## Migrating from the LAN9117 to the LAN9211

The purpose of this application note is to assist Microchip customers with existing LAN9117 designs when upgrading to the new LAN9211 devices. Migrating from the LAN9117 to the LAN9211 will require PCB modifications to support the new LAN9211 package type and the HP Auto-MDIX PHY (even if this mode is not used). This application note addresses all the differences between the LAN9117 and the LAN9211 devices, making this transition as easy as possible.

# AN 17.10

**FIGURE 1: PCB LAND PATTERN**

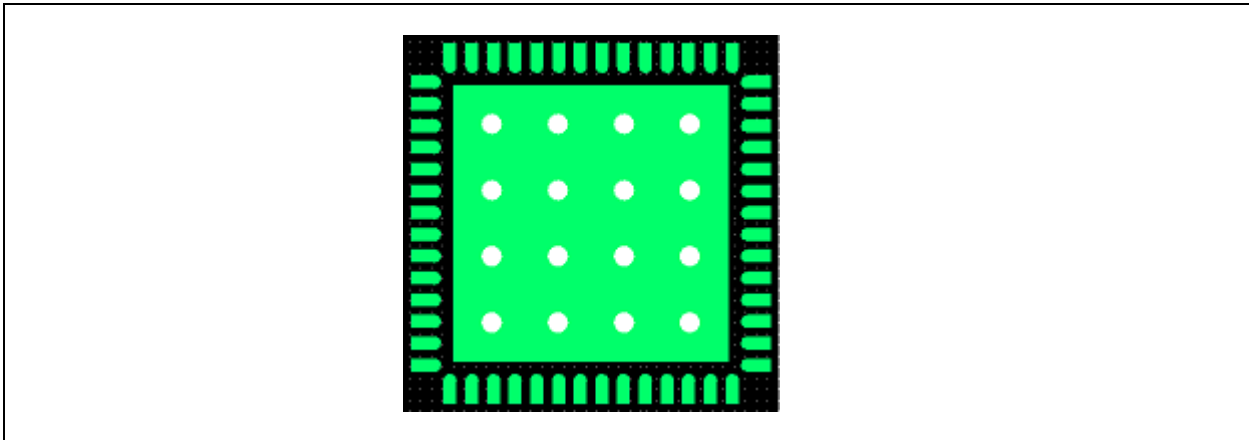
The LAN9211 is packaged in a 56-pin QFN with an exposed VSS pad. Therefore, the LAN9211 is not a drop in replacement for the LAN9117 and will require a new PCB. The recommended PCB land pattern can be found in Chapter 8 of the LAN9211 Data Sheet. It is recommended to place a 4x4 grid of vias at 60mil spacing in the exposed pad area for connection to the board's ground plane, as shown in [Figure 1](#) below. Please consult with your Assembly House for their process capabilities and recommendations.

FIGURE 2: LAN9211 TRANSMIT CIRCUIT

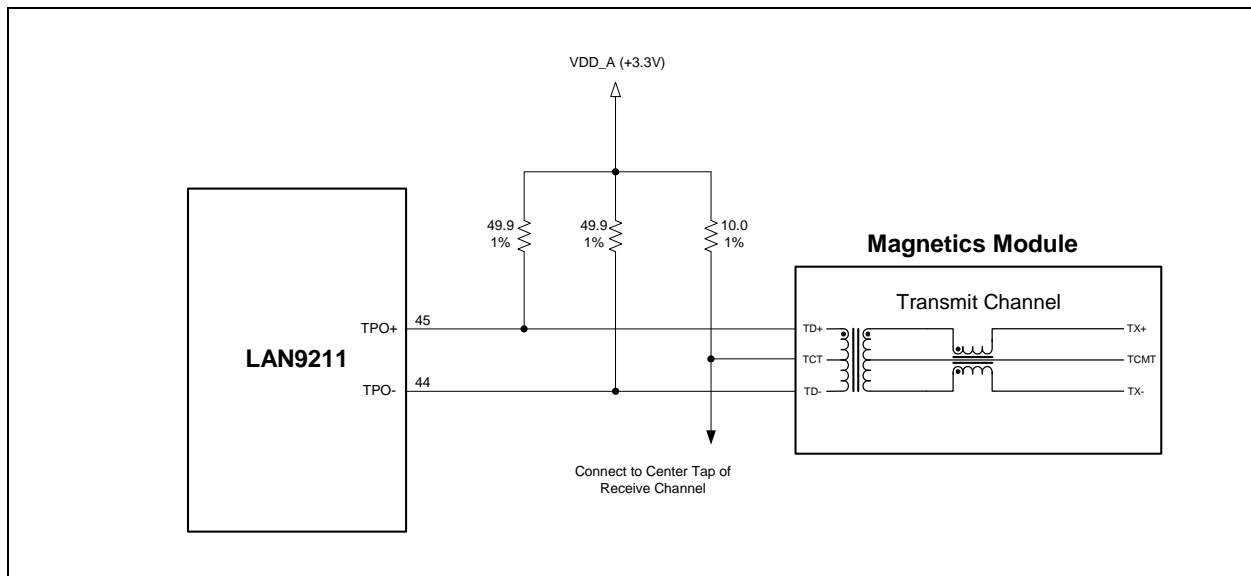
The transmit circuit used by the LAN9211, as shown in [Figure 2](#) below, is similar to that of the LAN9117.

- The LAN9211 uses magnetics that support HP Auto-MDIX.
- The device-side center tap of the transmit core (TCT) is attached to the device-side center-tap of the receive core (RCT).
- The 49.9 ohm resistors should be placed as close as possible to the LAN9211.

**FIGURE 3: LAN9211 RECEIVE CIRCUIT**

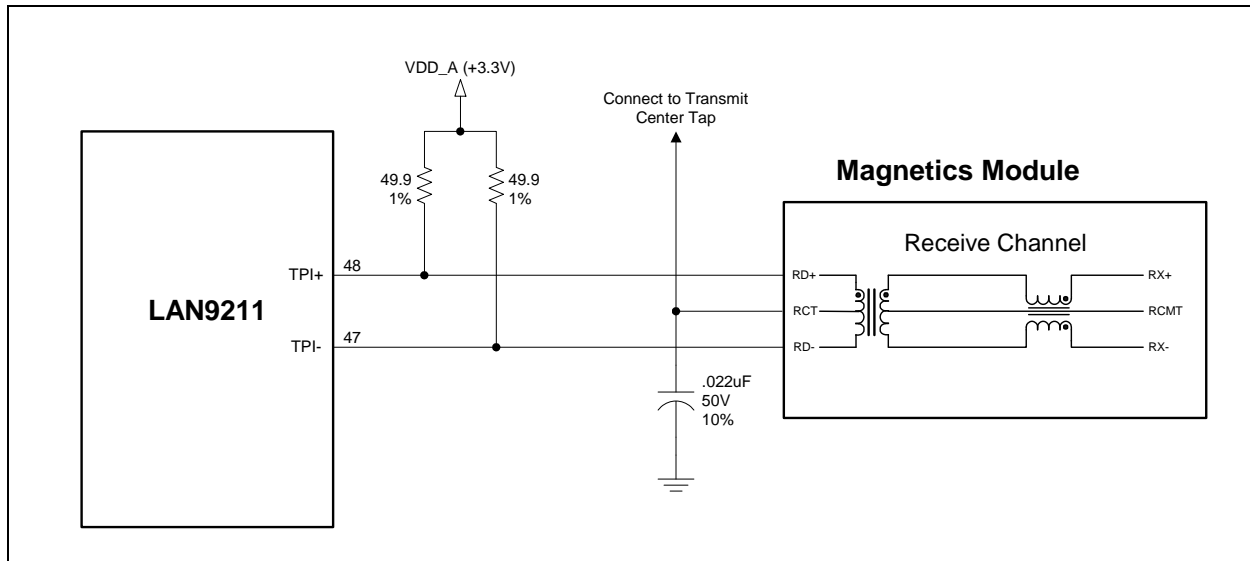
The receive circuit used by the LAN9211, as shown in [Figure 3](#) below, is similar to that of the LAN9117.

- The LAN9211 uses magnetics that support HP Auto-MDIX.
- The LAN9117 had two 6.8nF capacitors, one in series with each side of the twisted pair. These are eliminated (shorted) in the LAN9211.
- In the LAN9117, the mid-point between the two 49.9 ohm resistors is tied to the center tap of the magnetics (RCT) and to a 0.01uF bypass capacitor to ground. In the LAN9211, both resistors are tied to VDD\_A (+3.3V), and the 0.01uF bypass capacitor has been eliminated. The center-tap of the receive channel of the magnetics is tied to the transmit center tap (TCT) and to a common 0.022uF bypass capacitor to ground.
- The 49.9 ohm resistors should be placed as close as possible to the LAN9211.

**FIGURE 4: POWER CONNECTIONS**

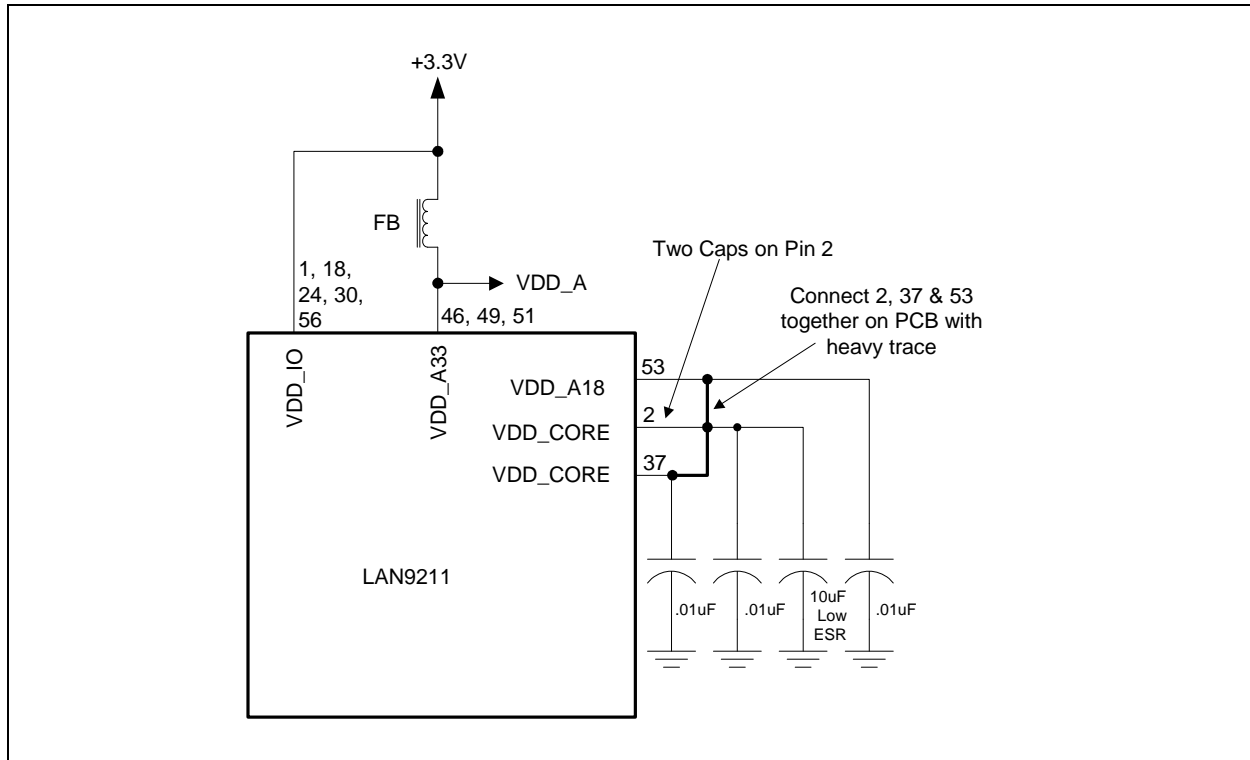
The LAN9211 has a VDD\_A18 (pin 53) that must be externally connected to VDD\_CORE (pins 2, 37) with traces at least 10 mil wide and connected to a 10uF low ESR ceramic capacitor. Each of these 3 pins must be individually decoupled with a 0.01uF capacitor as close as possible to the pin, as shown in [Figure 4](#).
